2CAN080302

SUBJECT: Arkansas Nuclear One, Unit 2
Docket No. 50-368
License No. NPF-6
Response to Request for Additional Information on Relaxation from Performing
a Bare Metal Visual Inspection on the ANO-2 Reactor Vessel Head

**Response to Request for Additional Information on Relaxation from Performing a
Bare Metal Visual Inspection on the ANO-2 Reactor Vessel Head**

Enlarged Excerpt of Page 14 of 43 from WesDyne Report WDI-TJ-007-02

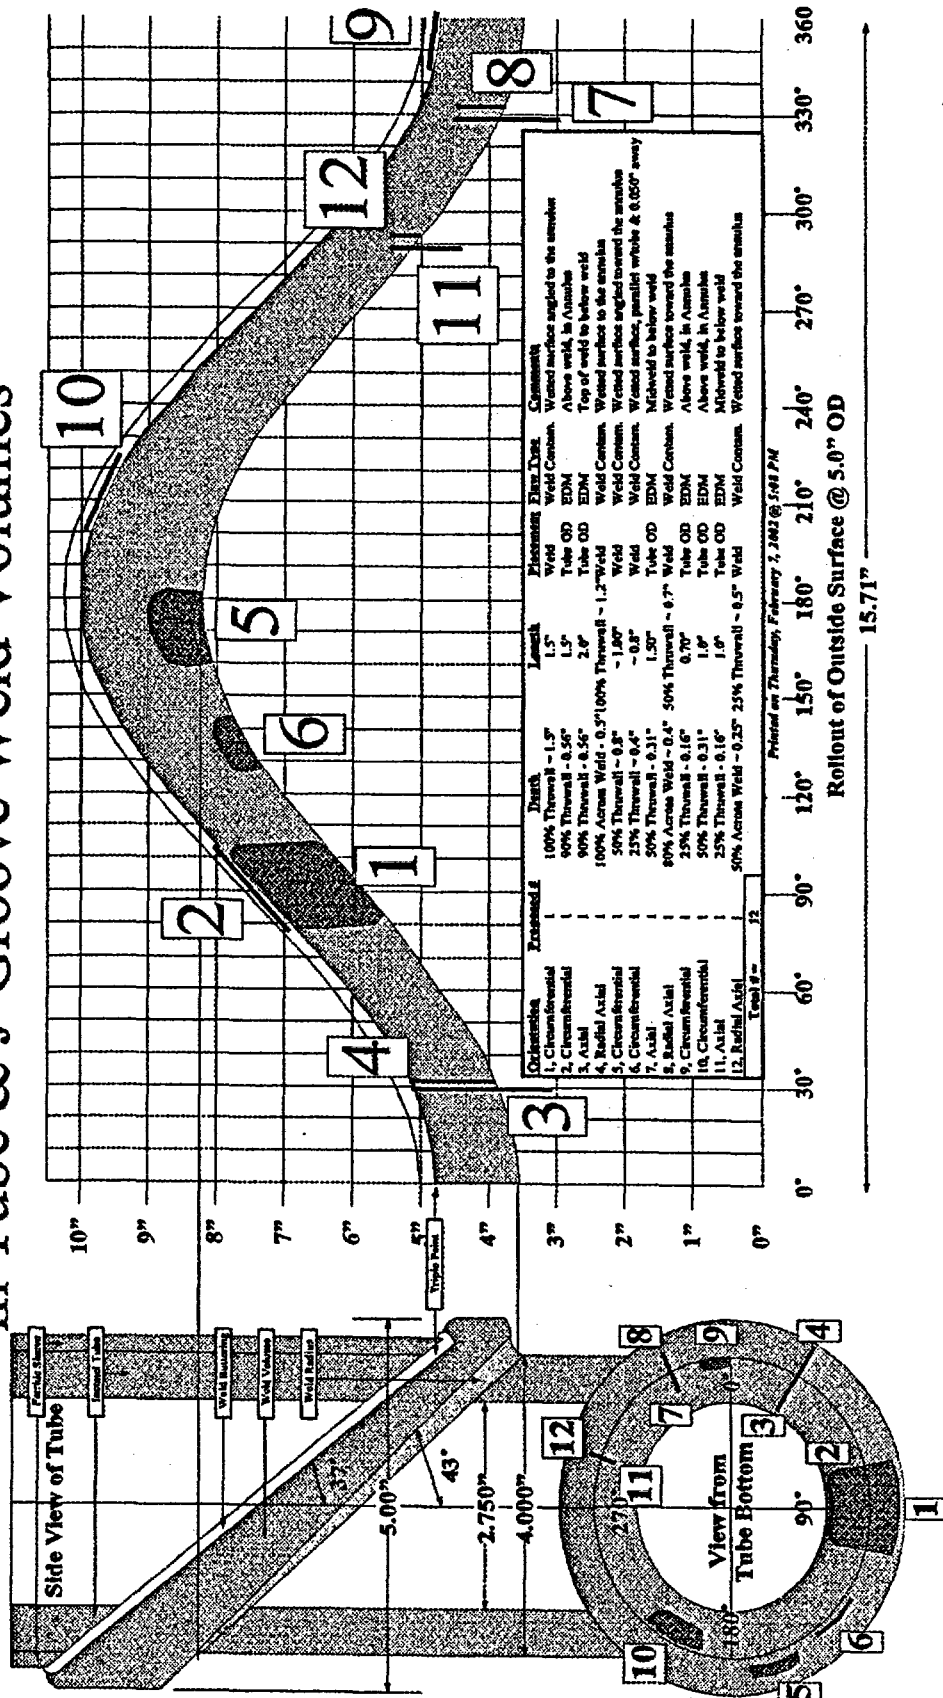
Previously, Entergy submitted WesDyne International Report WDI-TJ-007-02-P Demonstration of Volumetric Ultrasonic Inspection of CRDM Nozzles Using The Open House Scanner for ANO-2, by letter dated June 17, 2002. The diagram on the bottom of page 14 of 43 is extremely difficult to read. Please provide a legible copy of page 14.

The excerpted portion of Page 14 of 43 of the WesDyne Report WDI-TJ-007-02, *Demonstration of Volumetric Ultrasonic Inspection of CRDM Nozzles Using the Open Housing Scanner for ANO-2* (originally provided in Reference 4) has been enlarged and is contained in Attachment 3.
